Village of Bayside  
9075 N. Regent Rd.  
Architectural Review Committee Meeting  
July 16, 2018  
Village Hall Board Room, 6:00 pm

**ARCHITECTURAL REVIEW COMMITTEE  
AGENDA**

<p>PROJECT/SITE OWNER: Richard Bromley</p> <p>PROJECT ADDRESS: 9257 N Waverly</p>	<p>PROJECT SUMMARY: New 20x20 composite deck, 14x30 detached garage w/ vinyl siding and shingles to match house, replaced part of driveway, new landscaping.</p>
---	--

<p><b>PROJECT/SITE OWNER:</b> Jessica Snyder</p> <p><b>PROJECT ADDRESS:</b> 9445 N Fairway Circle</p>	<p><b>PROJECT SUMMARY:</b> Replacement and new fence. 6' tall, cedar picket, 318' long, 0% open design</p>
---	--

## PLAT OF SURVEY

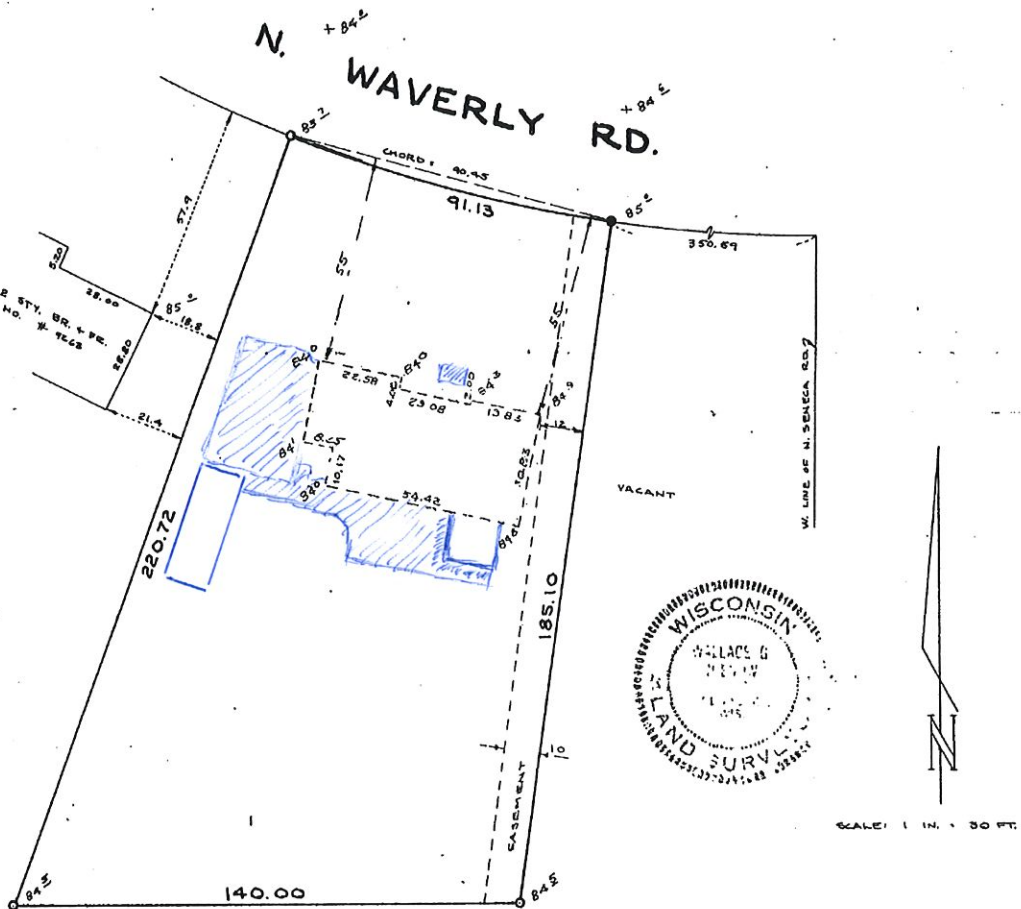
Exact dimensions are not provided for the location of the detached garage. Village code section 125-90 - "B" residence district regulations requires that accessory structures be located a minimum of 10ft from both rear yard and side yard property lines. Verify dimensions.

### SKETCH

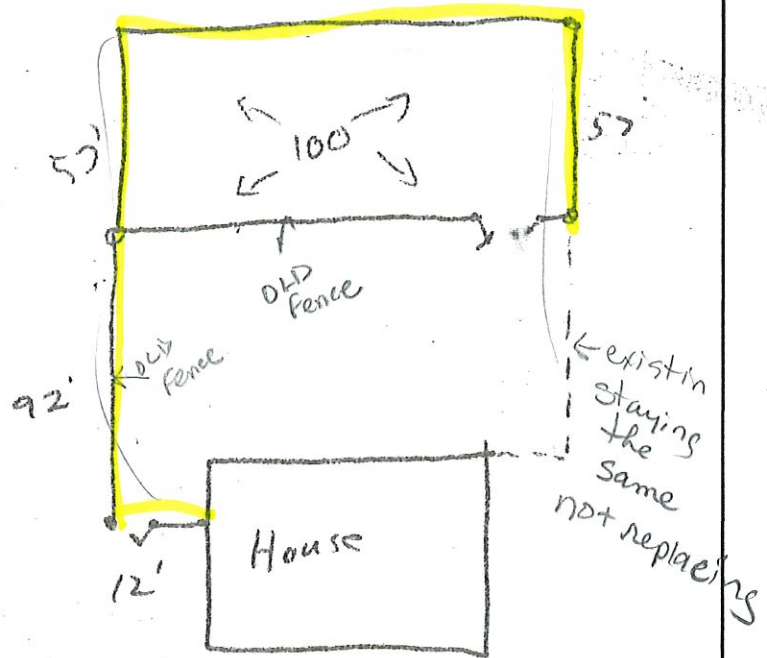
Proposed length of 318' is approximately 50% of the total property perimeter length of approximately 640' and a 50% open design is required by the code section copied below. A privacy fence is proposed which does not comply with the code section below.

**PROPOSED LENGTH AND TYPE DO NOT COMPLY**
